Introduction

This document describes the changes introduced with the new software version.

- **Product:** EK80
- **Software version:** 1.12.2

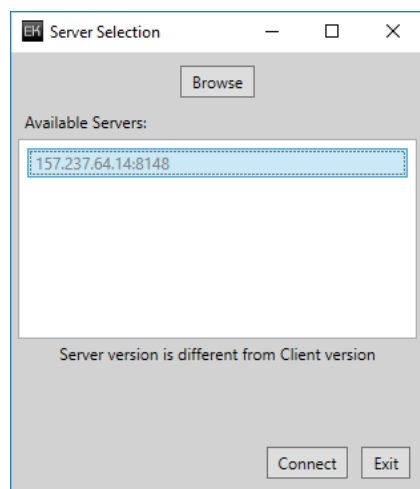
- **Improved handling of towed transducer**

Support for towed transducers has been added. In the transducer **Installation dialog** select mounting **Towed**. If depth of towed body is provided by a sensor, input the depth in terms of an NMEA DPT datagram, using the second field, "Offset from transducer". Alternatively, set depth manually in the **Sensor Configuration dialog**, Towed Body Depth section.
